Landfill 26 Soil Gas Feasibility Study Hamilton Army Airfield, Novato, California

Please find enclosed the Final, Landfill 26 Soil Gas Feasibility Study, Hamilton Army Airfield, Novato, California, for your review and concurrence. Modifications to the feasibility study were made based on regulatory agency comments received on the draft final version of this document. Significant changes to the document include:

Formal responses to comments on the draft final are provided in Appendix E. We would like to obtain your concurrence on this document by November 5, 2007. If you have any questions regarding this document, please feel free to call me at (916) 557-6965.

FIGURE 1-7
CONCEPTUAL SITE MODEL - IDENTIFICATION
OF POTENTIALLY COMPLETE EXPOSURE
PATHWAYS FOR SOIL GAS
 LANDFILL 26 SOIL GAS FEASIBILITY STUDY
 FORMER HAMILTON ARMY AIRFIELD
 NOVATO, CALIFORNIA

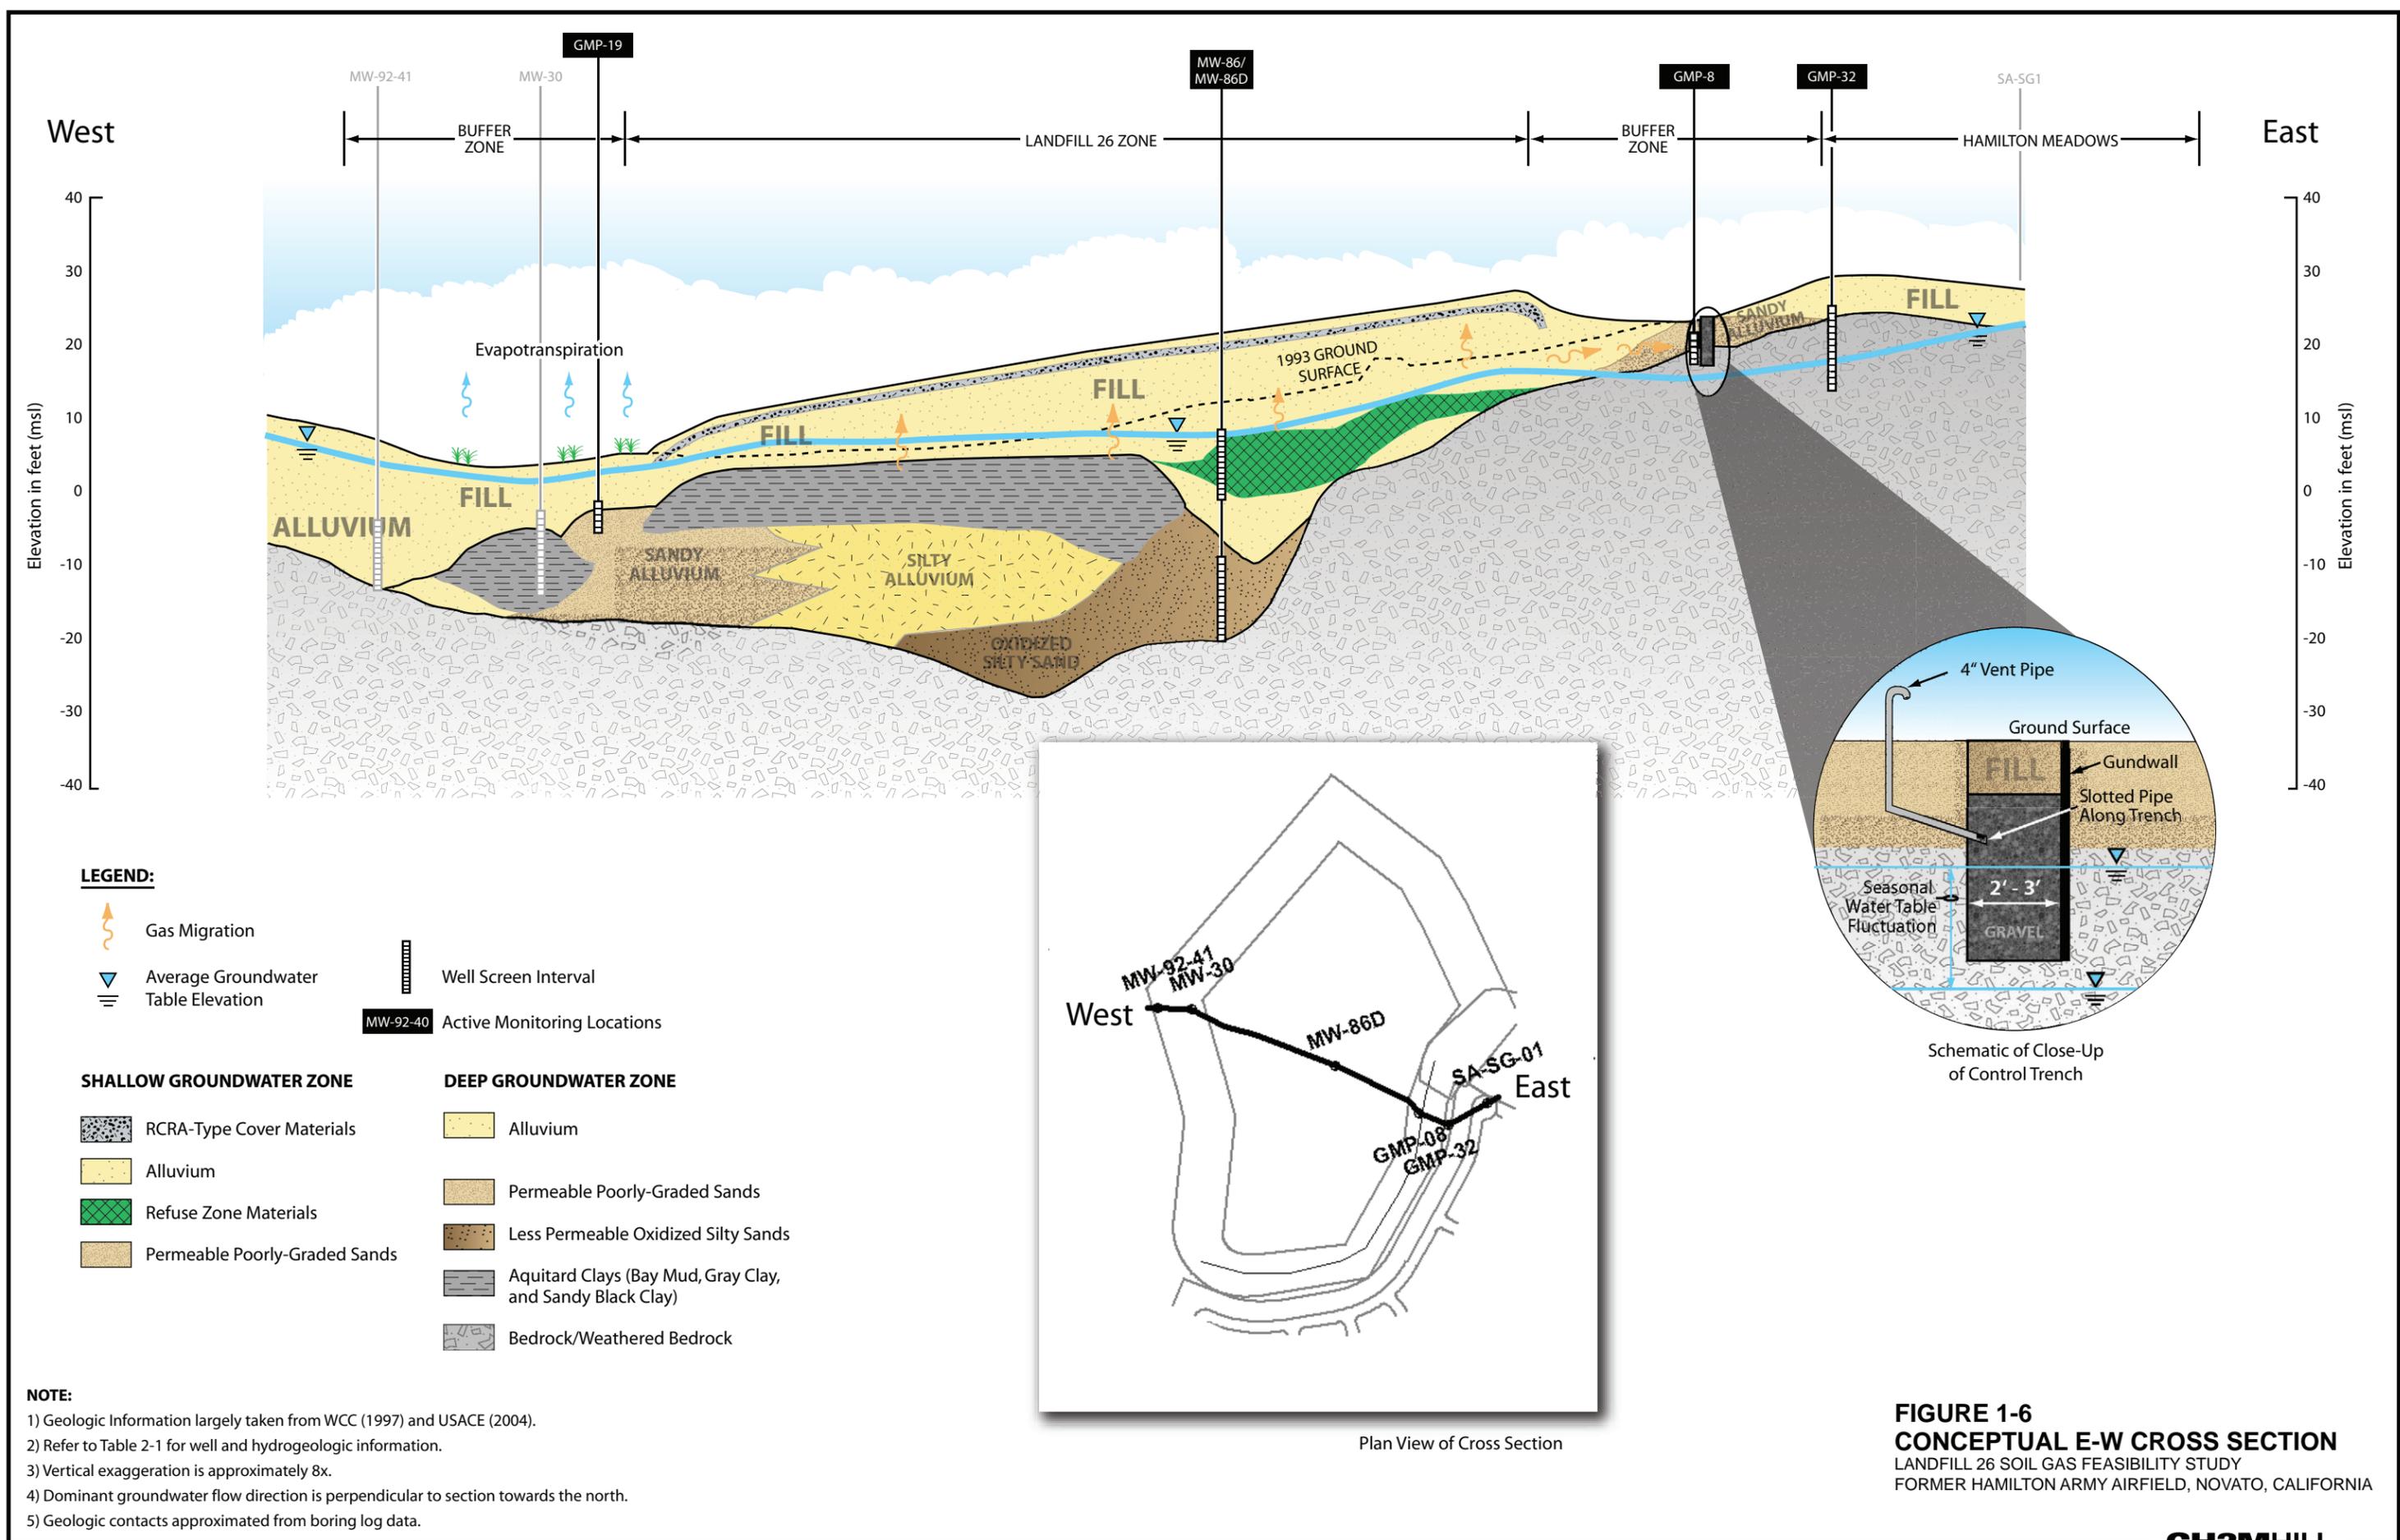
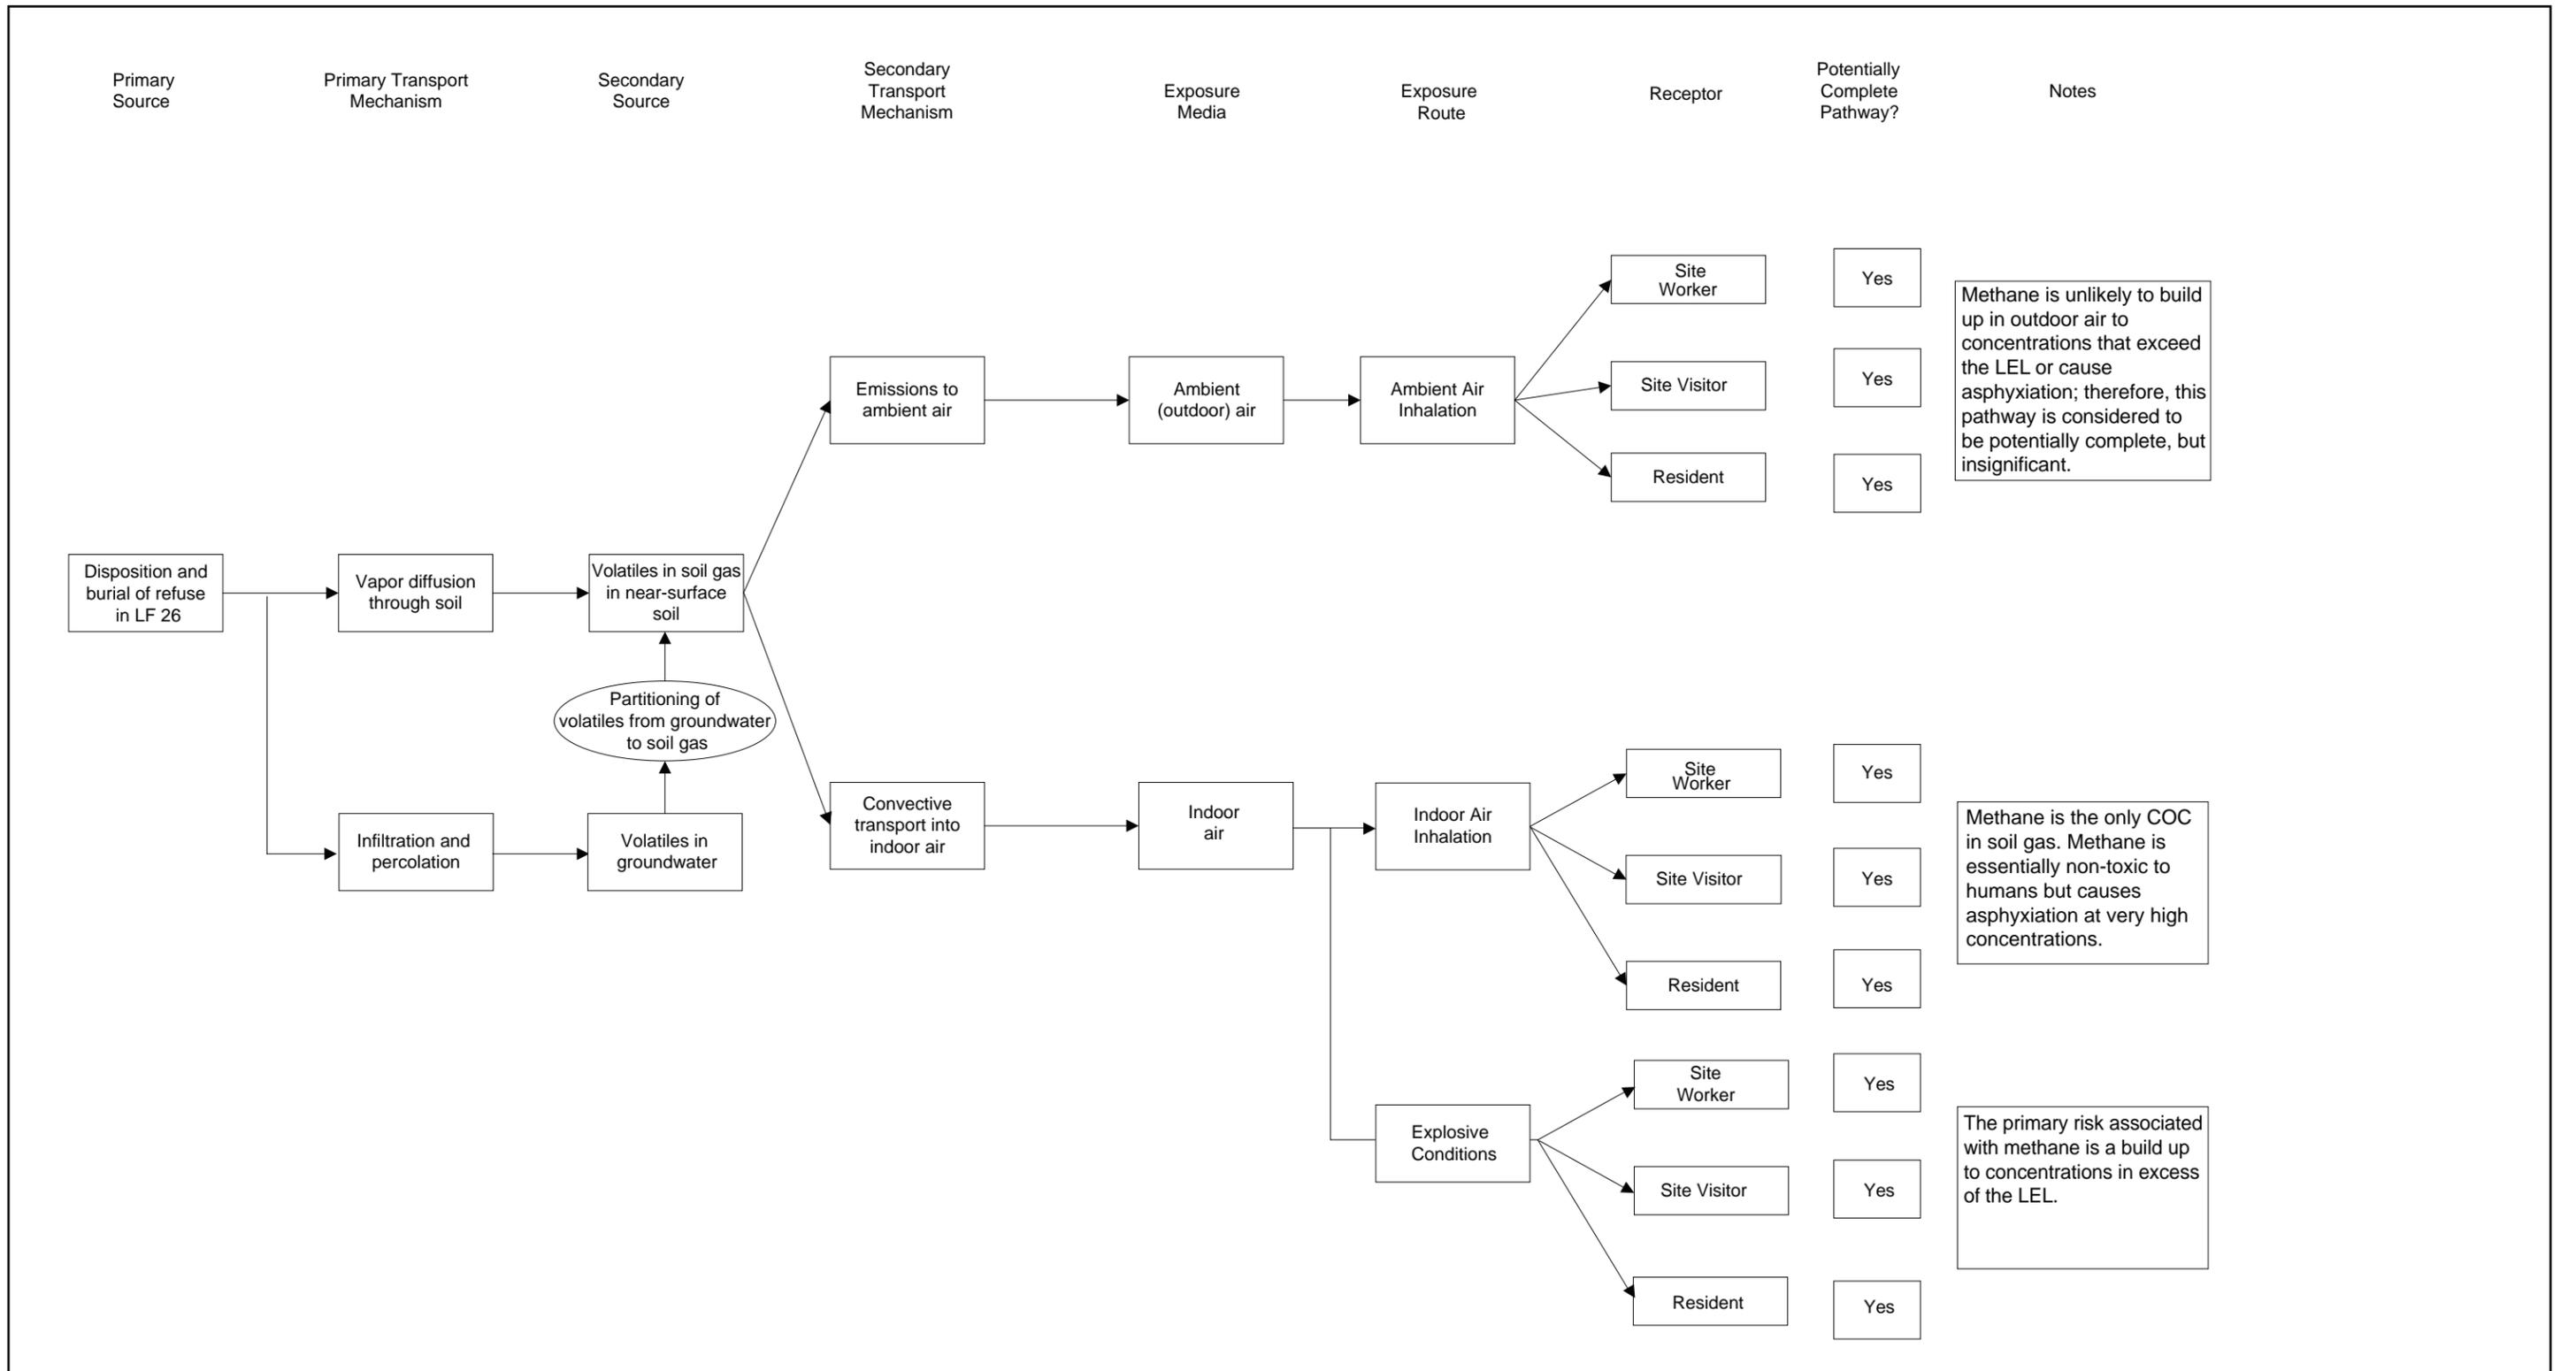
<p>4. <u>Conceptual Site Model (CSM, Figure 1-9).</u></p> <p>a. <u>COPCs.</u> Currently, only methane is discussed in the notes for the CSM. HERD recommends that VOCs (other than methane) also be listed.</p>	<p>Please see response to General Comment #3.</p>

<p>4. <u>Conceptual Site Model (CSM, Figure 1-9).</u></p> <p>b. <u>Environmental Media Considered in the Human Health Risk valuation.</u> This FS focuses <i>solely</i> on landfill refuse-related soil gas contamination at the LF 26 site. That is, the only medium evaluated for human exposure was soil gas. Pathways stated to have been considered in the FS consisted of impacts to human health via inhalation of volatile organic compounds (VOCs) in indoor and outdoor air, and explosive conditions caused by methane. We have the following comments:</p> <ul style="list-style-type: none">i Other than potential volatilization of VOCs from groundwater and partitioning of VOCs from soil to soil gas, risk associated with exposure to potential groundwater and soil contaminants has not been addressed in this document. If media at the site other than soil gas are contaminated, the risk estimates included in this document would not be representative of the cumulative total risk at the site.ii As HERD has noted for other sites in the vicinity of LF 26, depending on the sampling methodology and depth of soil gas sampling, evaluation of the indoor air pathway using soil gas data only may underestimate risk from this exposure pathway if VOCs are present in groundwater.iii Typically, HERD requires that cumulative total risk across all media be reported. Because the FS addresses soil gas only, we will defer to OMF on this issue but recommend that OMF consider this during risk management decisions at the site. This issue may be a potential data gap.	<p>4bi: As indicated in the FS, the only media addressed in this document is soil gas. Potential risks associated with other media (e.g., soil and groundwater) have been addressed in other documents prepared for LF 26 and by remedial measures that have been implemented at the landfill (e.g., the RCRA-type cap to mitigate potential risks associated with exposure to soil). The assessment of overall risks associated with all media of concern and the remedies selected to mitigate the identified risks will be documented in the forthcoming Proposed Plan and Record of Decision (ROD) Amendment.</p> <p>4bii: Potential risks associated with the indoor air pathway were evaluated using an extensive set of actual soil gas data. It is unclear to the Army how the use of actual soil gas data could result in underestimation of potential risks via the indoor air pathway (given that there are no structures currently located within the footprint of the landfill).</p> <p>4biii: Please see the response provided above regarding the assessment of cumulative risk.</p>

<p>4. <u>Conceptual Site Model (CSM, Figure 1-9).</u></p> <p>c. <u>Human Receptors and Exposure Pathways.</u> The CSM lists site worker, site visitor, and residents as potential receptors. Appendix A includes the USACE's evaluation of vapor intrusion to indoor air for future residential receptors. Also included in Appendix A is a 2002 human health risk screening analysis for outdoor ambient air impacted by the trench vents from the prepared by the Bay Area Air Quality Management District (BAAQMD). HERD did not review the BAAQMD evaluation in detail as we do not have expertise in landfill emissions modeling (see General Comment 5 below).</p> <p>i. The CSM does not list construction / trench workers as potential future receptors at the site. Per discussions with OMF, HERD understands that a land use restriction will be place for the landfill and buffer zone against future uses other than landfill / open space as part of the Record of Decision (ROD). If it is determined that construction may occur at the site in the future, HERD recommends evaluating a construction / trench worker scenario in the HHRA. This is particularly important given the presence of VOCs and methane at the site. For example, while it may be unlikely that methane would be present in outdoor ambient air at concentrations exceeding the lower explosive limit (LEL) or a concentration needed for asphyxiation due to dispersion and dilution, it is unclear whether this would be true for trench workers.</p> <p>ii In general, HERD finds it likely that if exposure to VOC in soil gas does not pose a significant risk to residents from the indoor air pathway, then exposure to VOCs in outdoor ambient air emitted from soil gas would also not pose a significant risk. However, in the absence of a quantitative evaluation using accepted risk assessment methodology, this cannot be confirmed. HERD also cannot comment on whether this would be true for construction/trench workers (should such activities be envisioned in the future).</p>	<p>4ci: A State land use covenant (SLUC) will prevent construction at the site. Therefore, a construction/trench worker is not a potential receptor of concern.</p> <p>4cii: The USACE concurs that if VOC in soil gas do not pose the potential for significant risk to residents via the indoor air pathway, that the potential for significant risk to an outdoor ambient air receptor is not likely. The outdoor ambient air pathway has been quantitatively addressed by the risk assessment performed by the BAAQMD. This assessment indicated that unacceptable risk would not occur. See response 4ci regarding a construction trench worker.</p>

<p>4. <u>Conceptual Site Model (CSM, Figure 1-9).</u></p> <p>To address this issue, the risk assessment should be updated to include an evaluation of the outdoor ambient air pathway for residential receptors (given that a residential scenario indoor air evaluation is currently included). In addition, since questions may arise from persons using the landfill area for recreation, HERD recommends that the recreational scenario be evaluated for the outdoor ambient air pathway if this pathway is shown to pose a significant risk/hazard to residential receptors. Finally, there are also other potential future exposure scenarios (e.g. industrial, construction) where the outdoor ambient air pathway may be complete if land use restrictions are not in place. If such restrictions are not currently in place or will not be in the future, those receptors need to be evaluated as appropriate. For the current scenario, HERD does not have knowledge of workers who may be present at the site for maintenance of the cap, trench, etc. This needs to be addressed to ensure a scenario protective of such workers will be evaluated.</p>	<p>As stated previously, the outdoor ambient air pathway has been quantitatively addressed by the risk assessment performed by the BAAQMD. This assessment indicated that unacceptable risk would not occur for residential receptors. Unacceptable risk would, therefore, not occur for lesser exposed receptors.</p>
